PLAN OF PROPOSED IMPROVEMENT

NINTH ADDITION TO BLACKHAWK SUBDIVISION - PLAT AND REZONE

CITY PROJECT NO. 11943

SHEET NO.
X-1

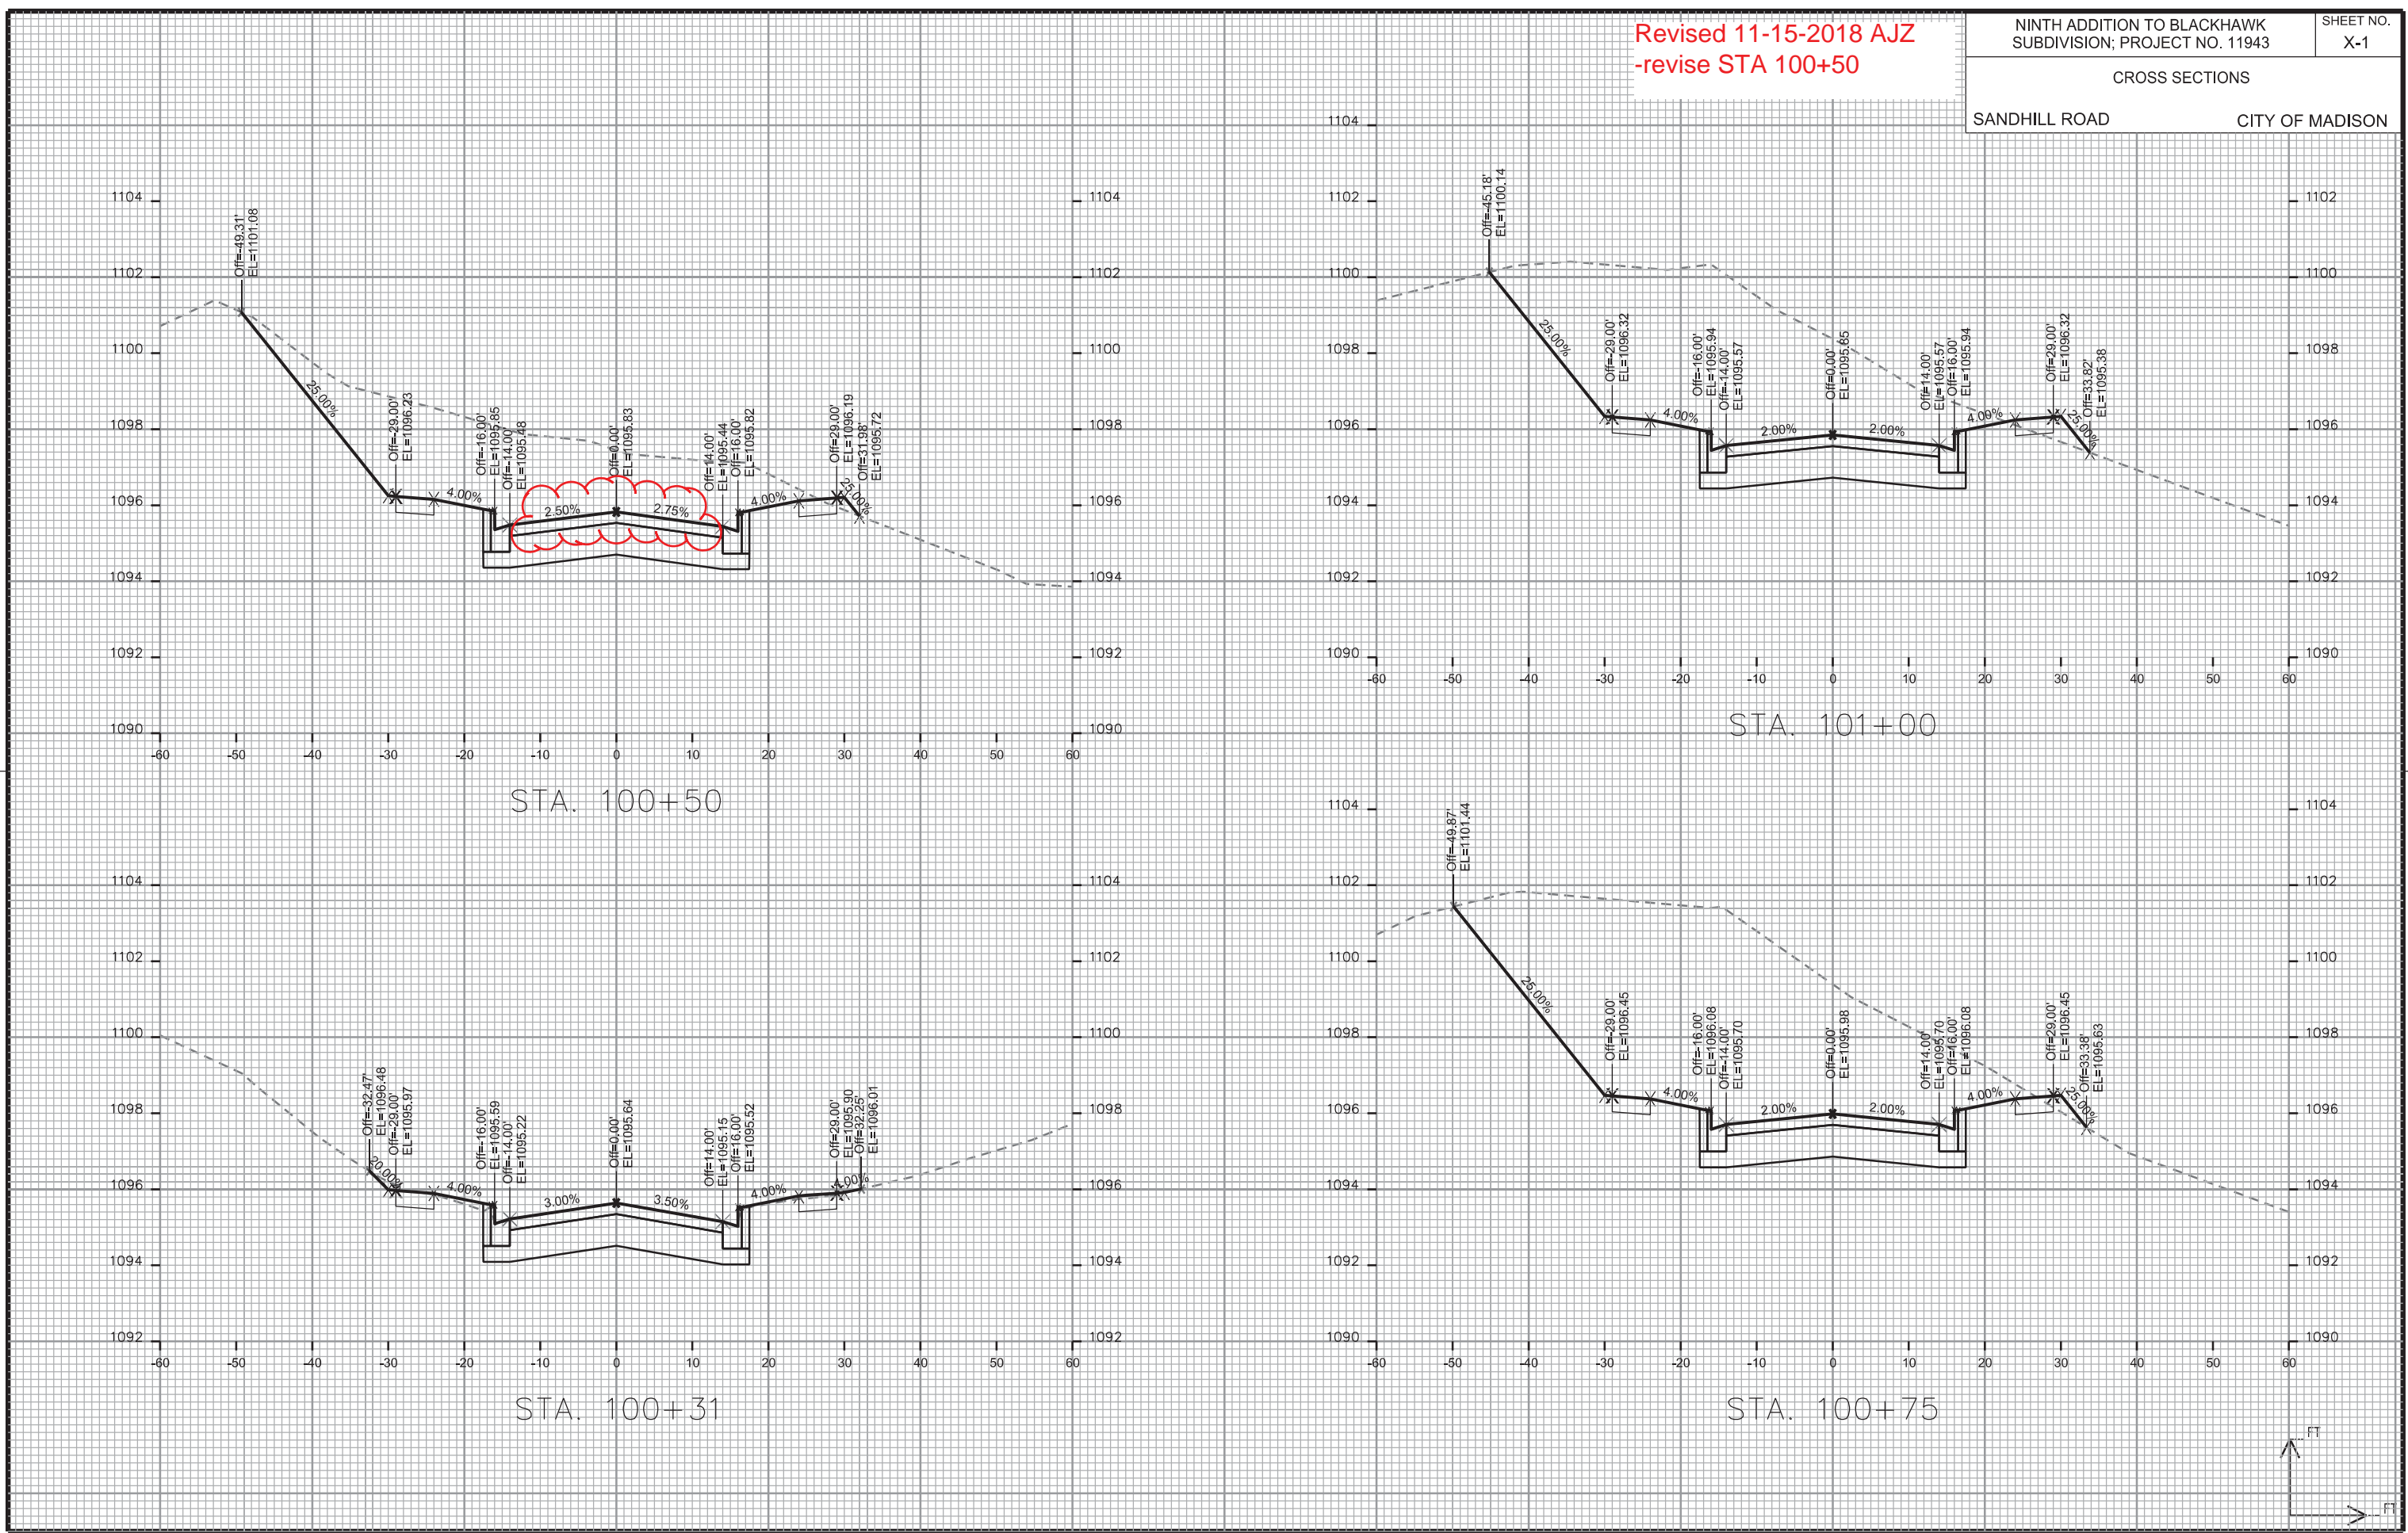
Revised 11-15-2018 AJZ
-revise STA 100+50

RED ROCK LANE

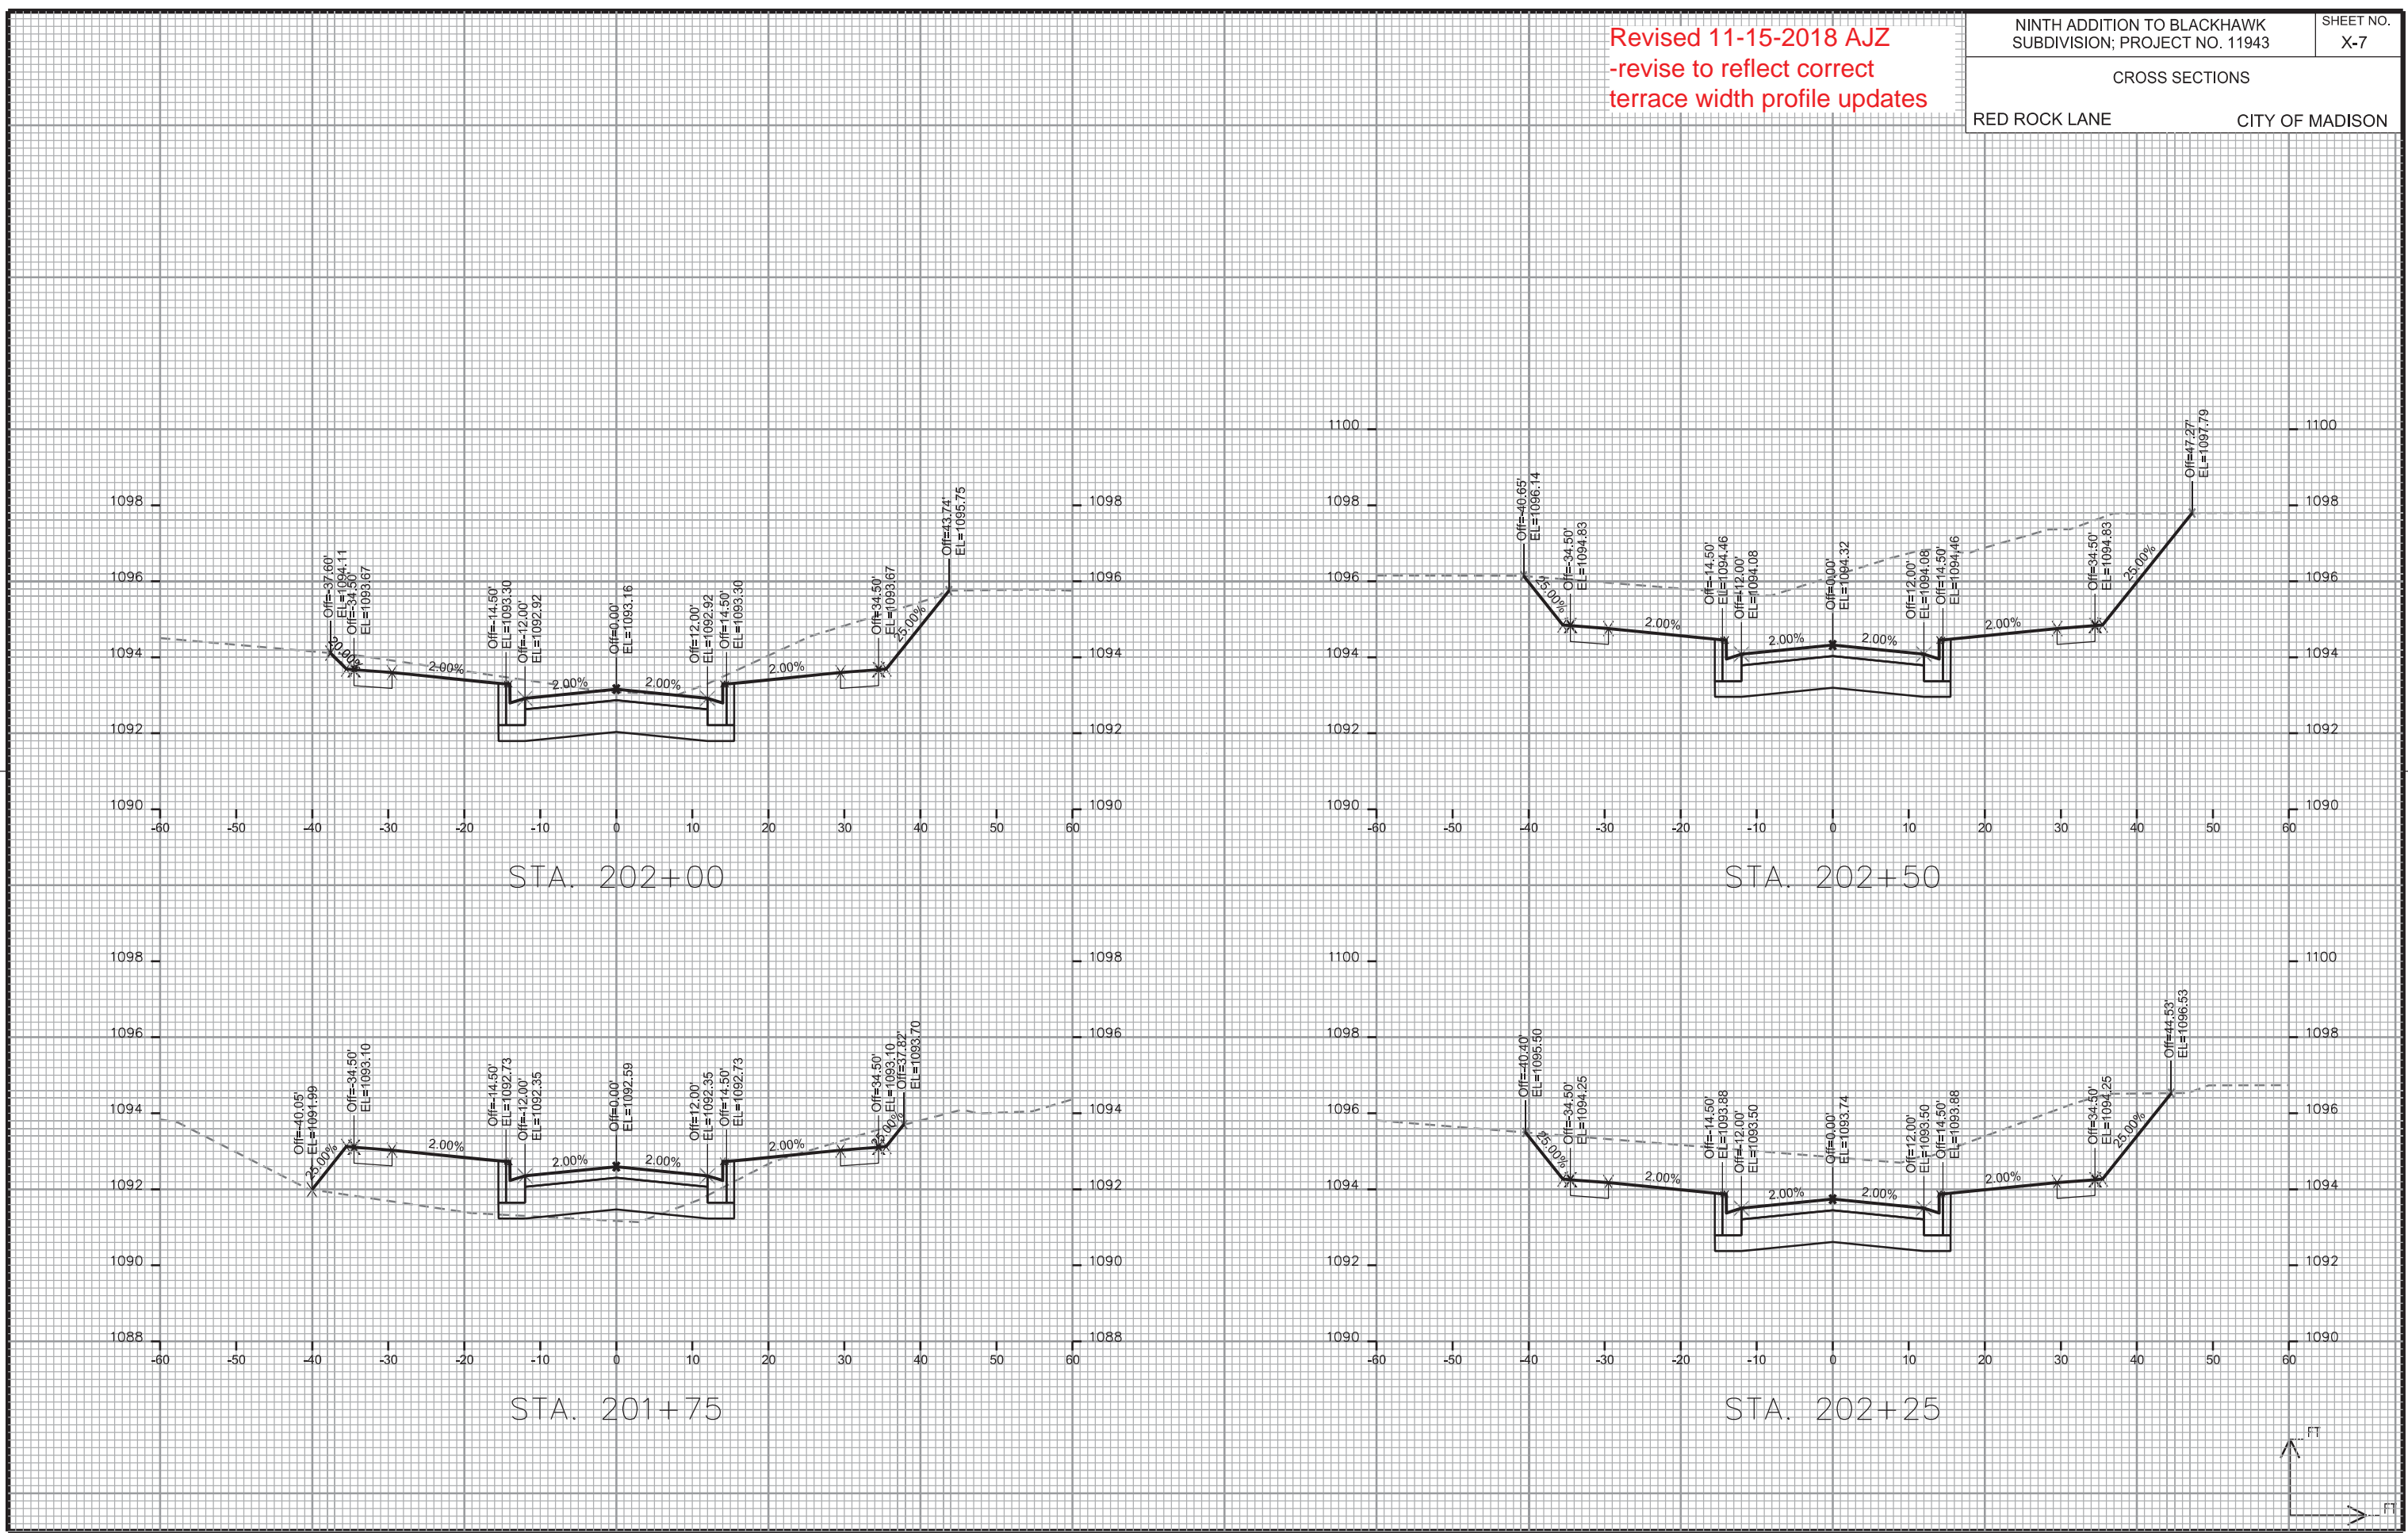
Revised 11-15-2018 AJZ
-revise to reflect correct
terrace width profile updates

SHEET NO.
X-8

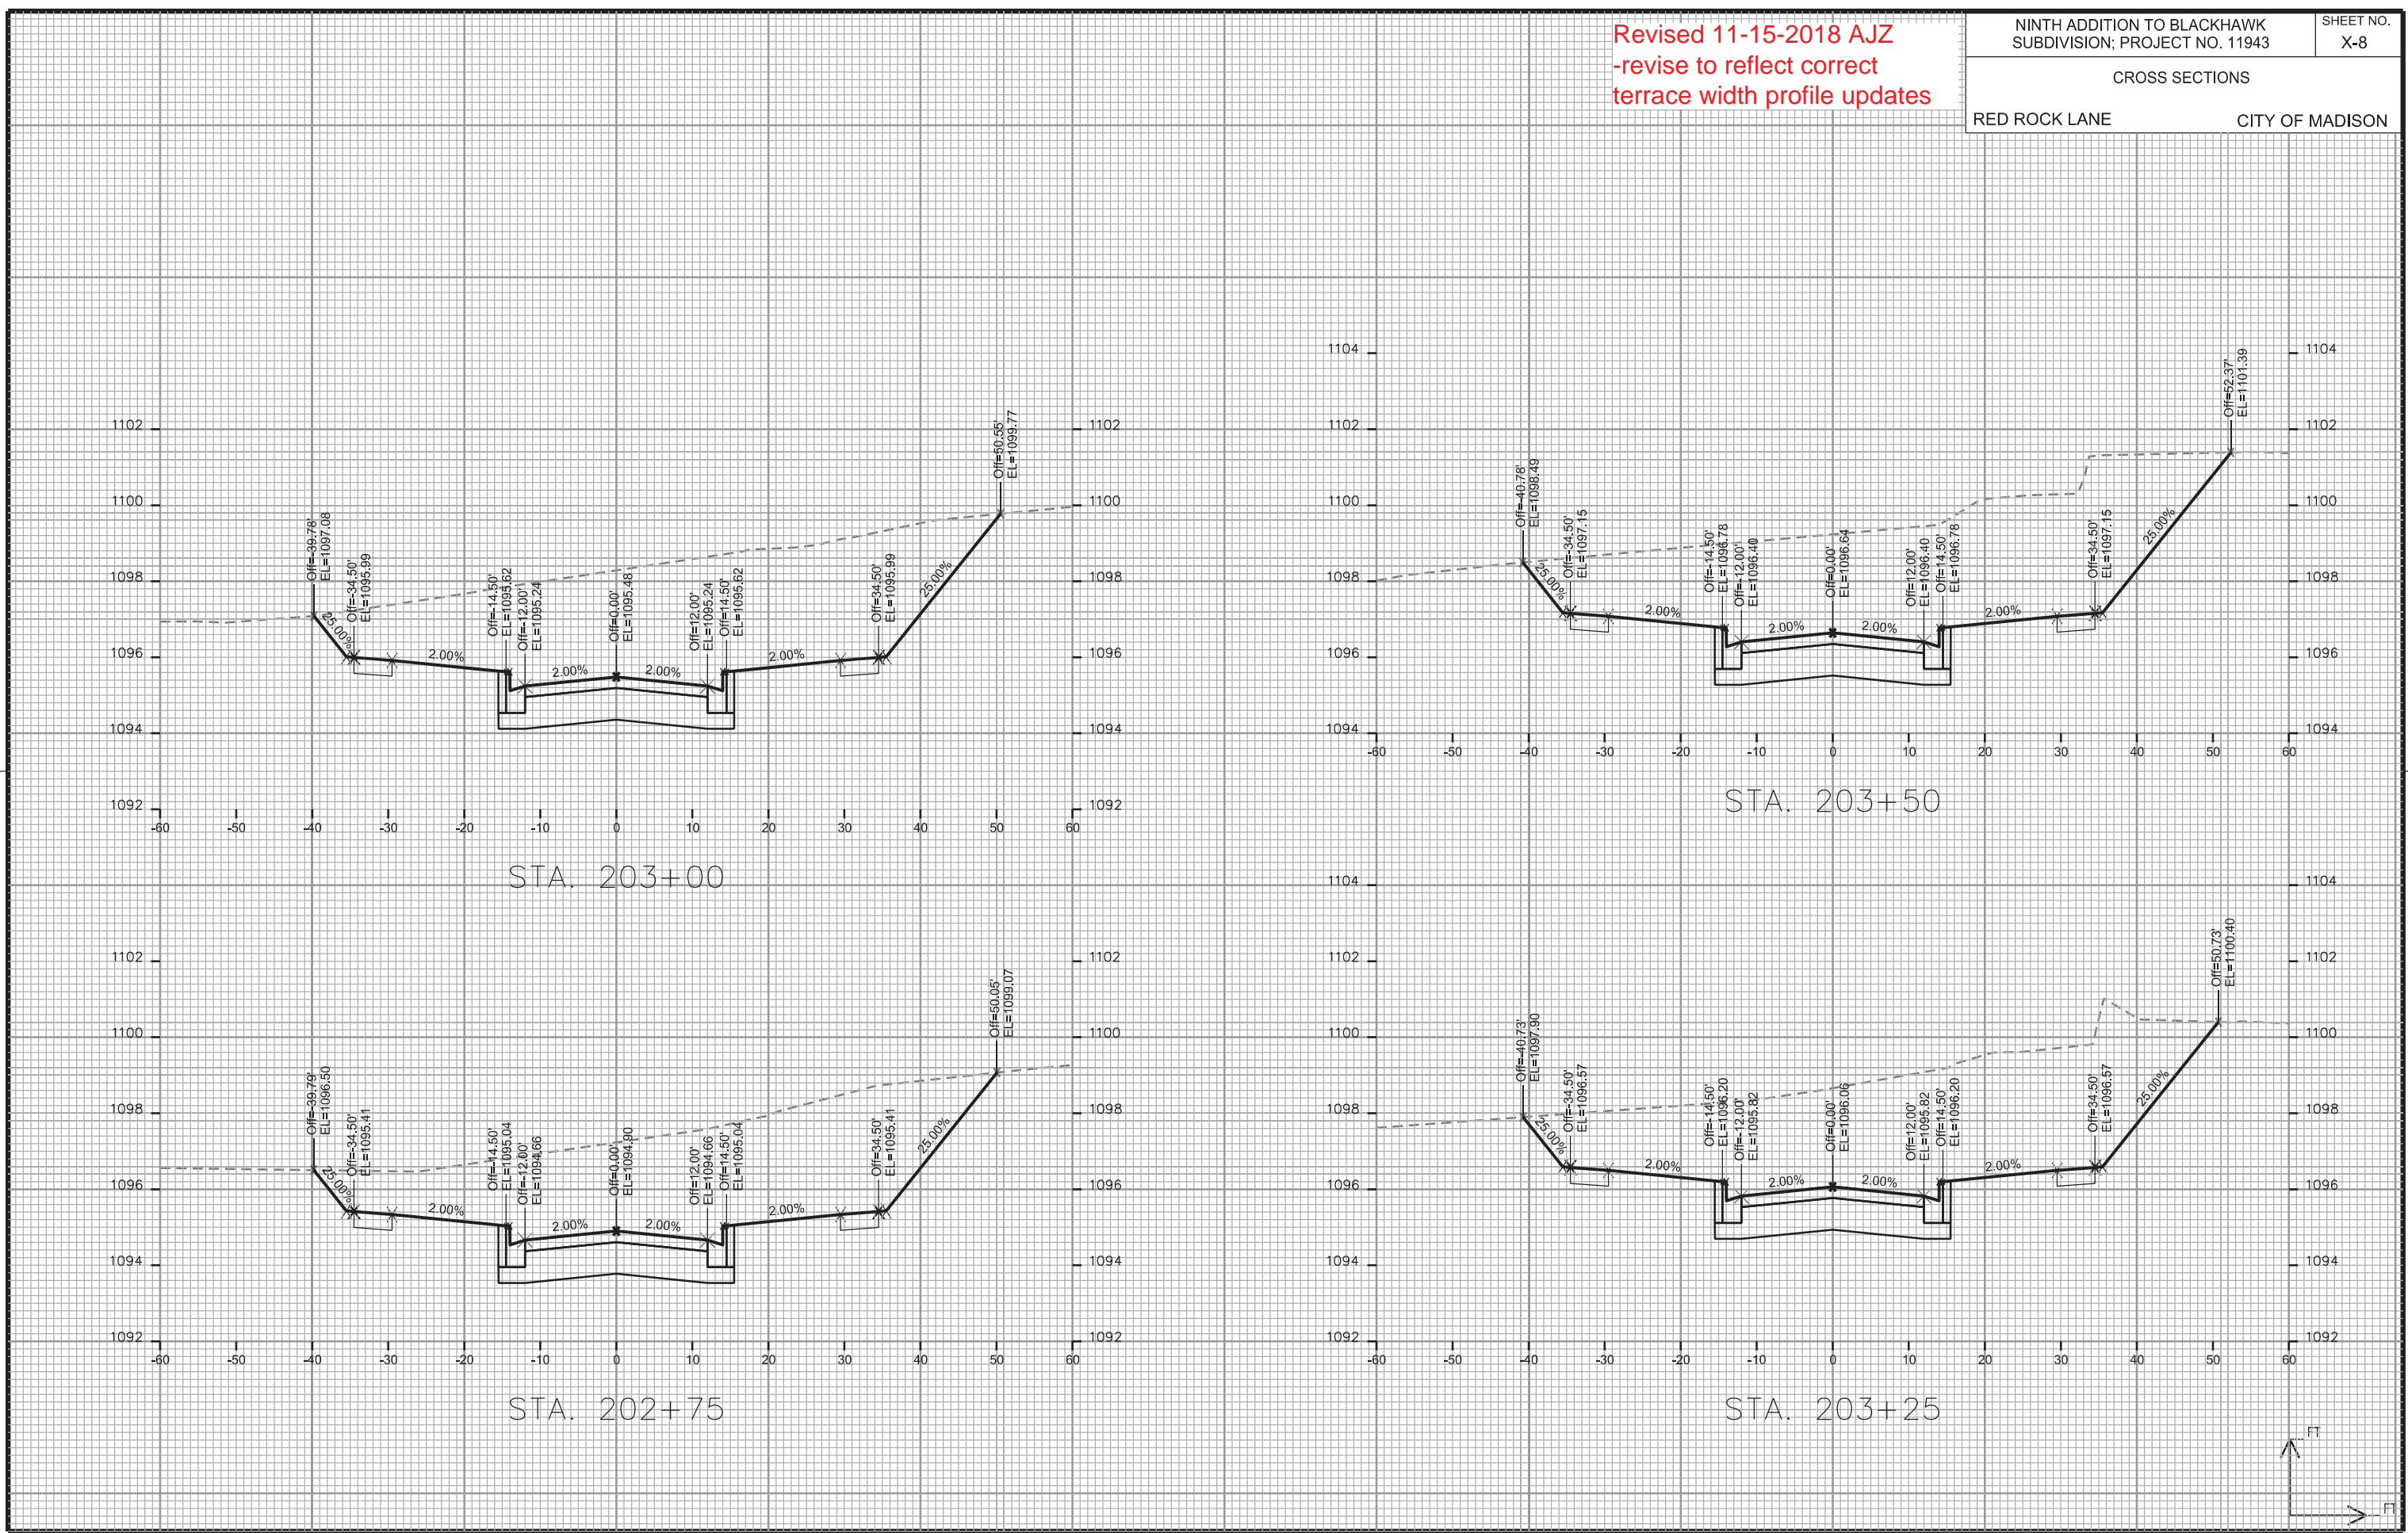
Revised 11-15-2018 AJZ
-revise to reflect correct
terrace width profile updates
